66103A-08

S E R V I C E N O T E

66103A DC Power Supply

The instrument will not communicate or will not complete self test.

Figure1

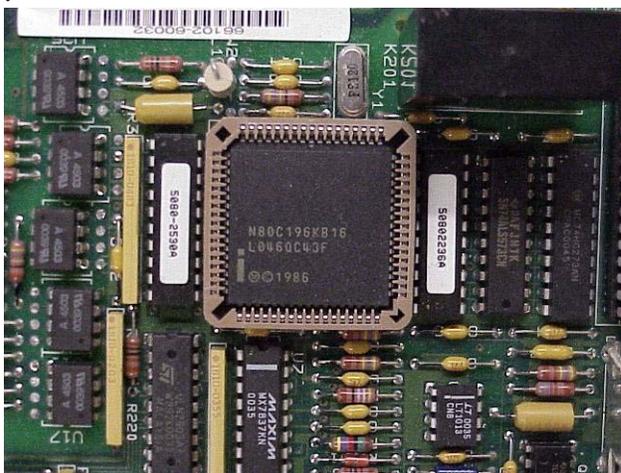
Figure 1 will help to identify the **68-PIN PLCC SOCKET location** - P/N 1200-1274 (Circuit Reference “U001”)

Figure 2

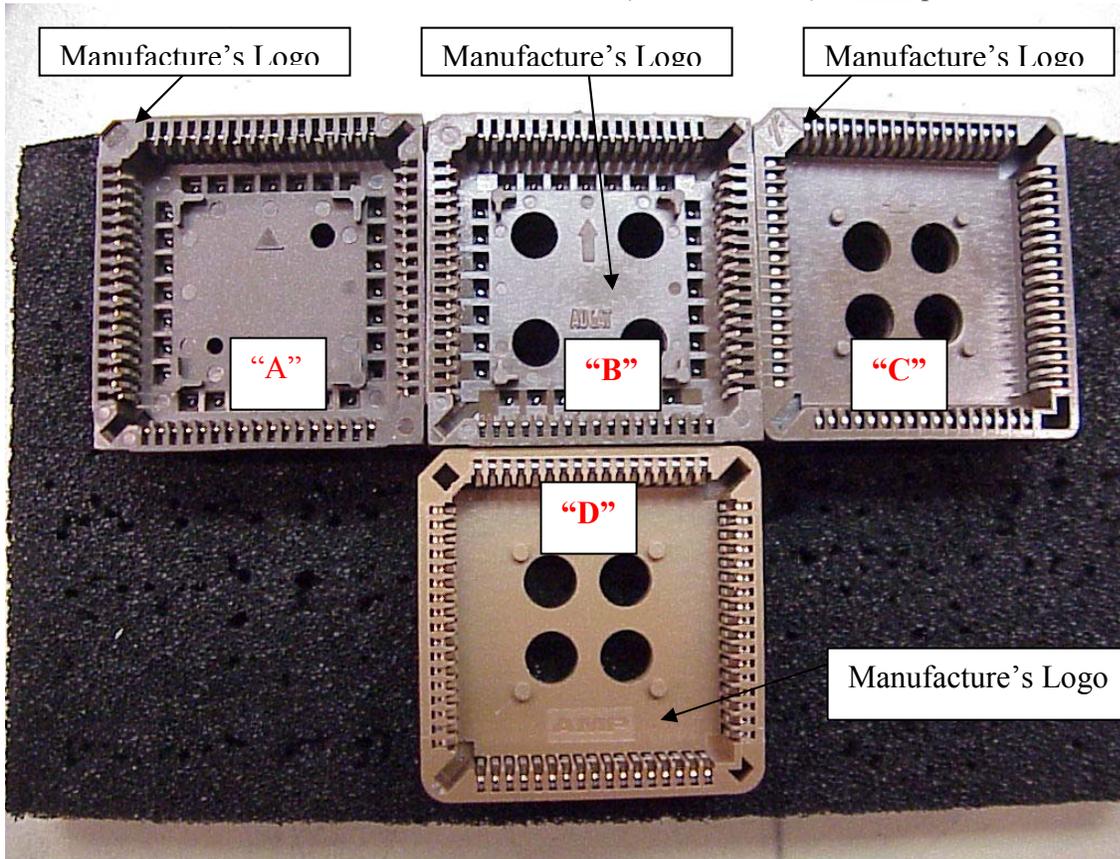
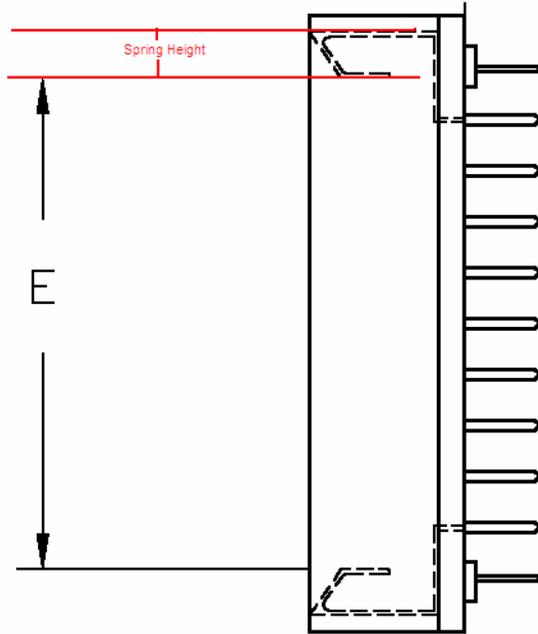
This figure should be used to identify **GOOD** sockets and a potential defective socket. The **16-Bit MCU 16 MHZ 68PLCC CMOS IC** (P/N 1821-1479) is **NOT** pictured.

The following information will help identify each socket type and manufacturer. The manufacturer's logo can be identified as shown. After the **16-Bit MCU 16 MHZ 68PLCC CMOS IC** has been removed there are also mold markings that can be easily viewed these markings should be used to identify a **Good or Defective socket**.

- Socket **"A"** is a sample of a GOOD AMP socket.
- Socket **"B"** is a sample of a GOOD Tyco/Augit socket.
- Socket **"C"** is a sample of a GOOD FCI socket.
- Socket **"D"** is a sample of a DEFECTIVE Tyco socket.

The sockets above labeled **"A", "B" or "C"** are good and should NOT be replaced. The socket above labeled **"D"** is considered defective should be replaced.

Any Model having a serial number starting and ending with the serial numbers shown in the chart below should have the socket 68-PIN PLCC SOCKET - P/N 1200-1274 (Circuit Reference "U001") **REPLACED!**

Discipline B – Verification of Corrective Action “The socket shown in the pictures are for reference ONLY”

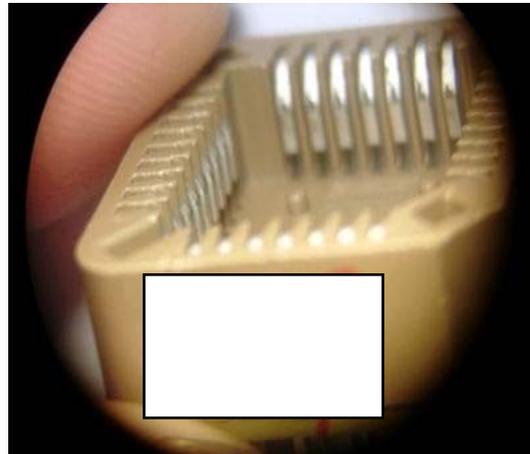
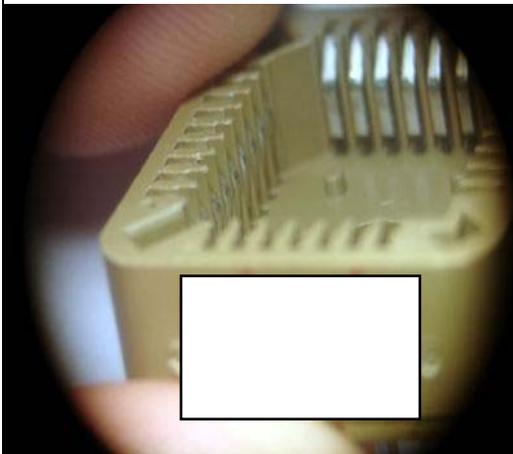
The condition of the recessed beams has been corrected by a design enhancement implemented in production. This design enhancement increased the spring height dimension by 0.04mm and decreased the spring height tolerance by 40%. The spring height dimension is shown in the drawing below.

This design enhancement is intended to position the contact beams closer to the middle of the socket and increase the normal force exerted on the contacts of the chips mated to the socket.

The effectiveness of this design enhancement was tested by comparing the mating and un-mating forces on the older and newer designs. The test results for sockets with the increased spring height (newer design) showed an increase in the mean mating force of 18.9% and an increase in the mean un-mating force of 23.4%. The increase in the un-mating force test results between the old design and the new design indicate that a greater normal force is being exerted on the test chip contacts by the socket contact beams. The two revisions of this contact beam design were visually examined after the mating and un-mating force testing. Photos of the two sockets are shown below. The photo on the left shows the older version socket prior to the enhanced contact beam design. The photo on the right shows a socket with the design enhancement. The contacts with the older design appear to be recessed farther into the housing after un-mating.

Material with this design enhancement will be labeled with a 2007 date code
